CLIENT	RAPHAEL CONTRACTING LTD
PROJECT	CENTRE POINT,103 NEW OXFORD ST.
SCALE	1-10,1-5 & 1-1.
DATE	21-11-2015
DRAWN BY	AJG
CHECKED BY	
DRAWING TITLE	Apartment type B,Penthouse Bathroom Type G,Room 9.Vanity Unit Type A, level 34.
PROJECT No	6538
REVISION	-
DRAWING No	E1003-81-CPT-XX-138
DRAWING STATUS	FOR APPROVAL

DOCUMENT REVIEW Brookfield MULTIPLEX BM

1.5 FRONT SECTION THROUGH B-B.

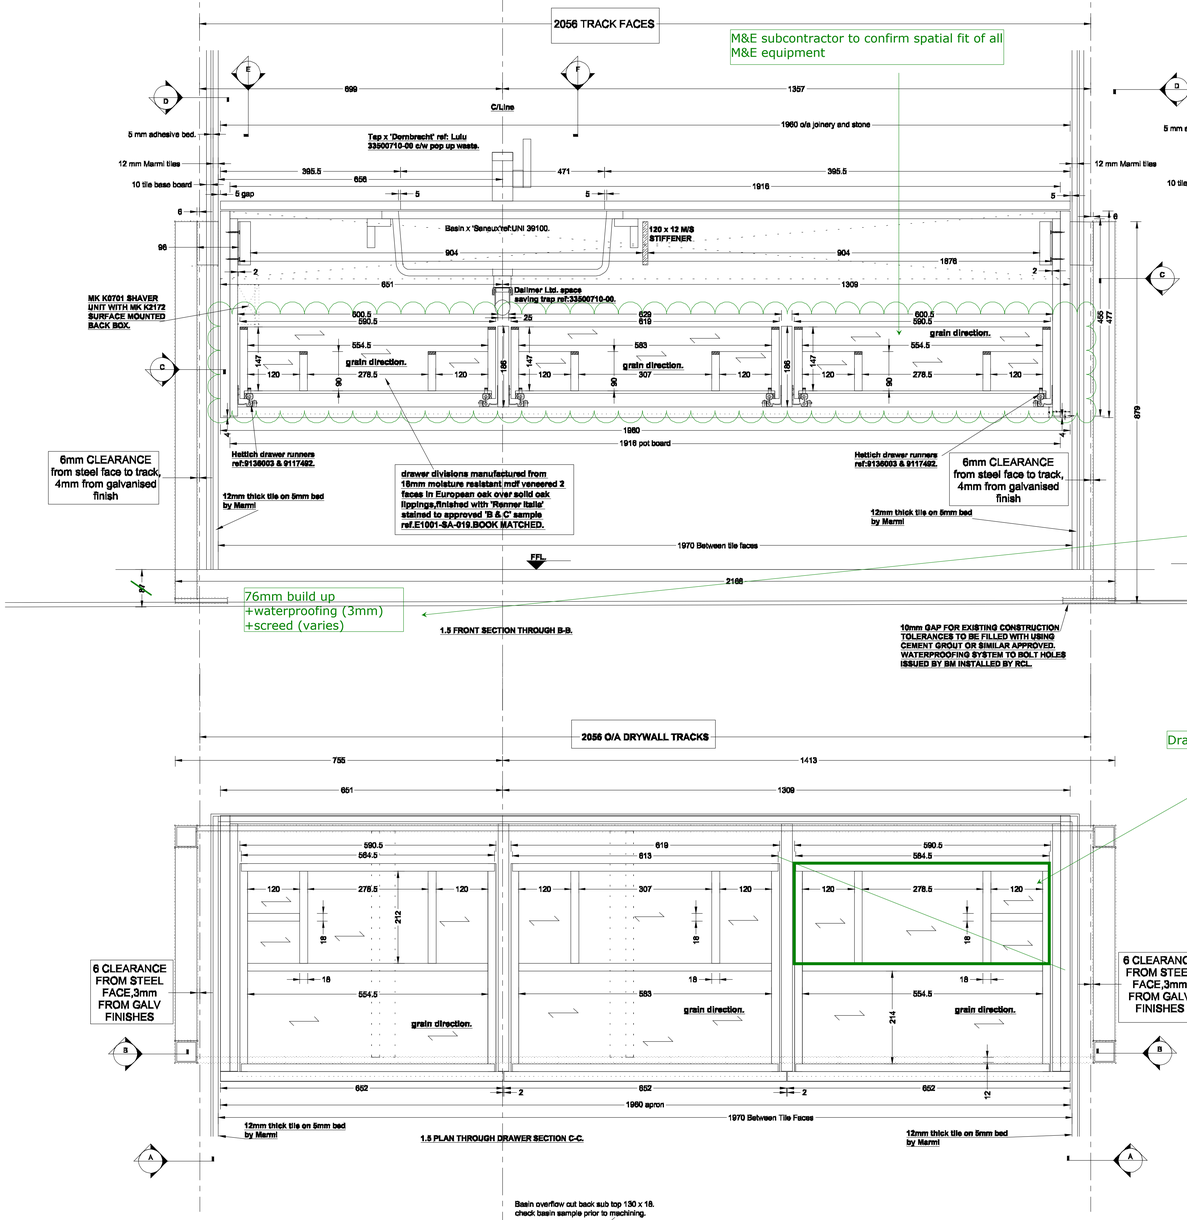
Drawer to be half depth

Drawer to be half depth- Rear compartment to be removed

1.5 FRONT ELEVATION. A-A

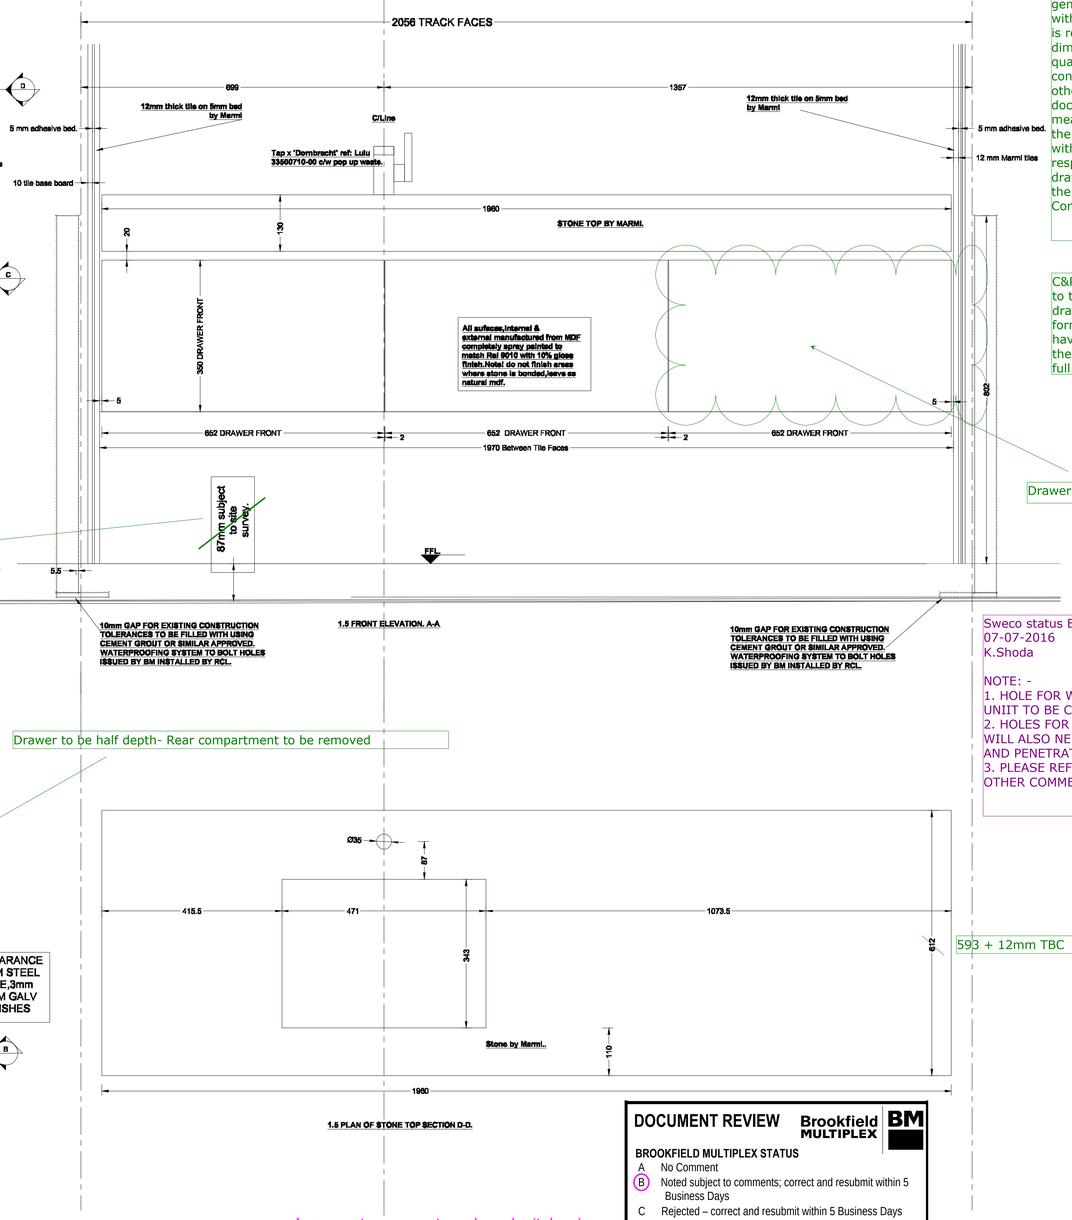
M&E subcontractor to confirm spatial fit of all M&E equipment
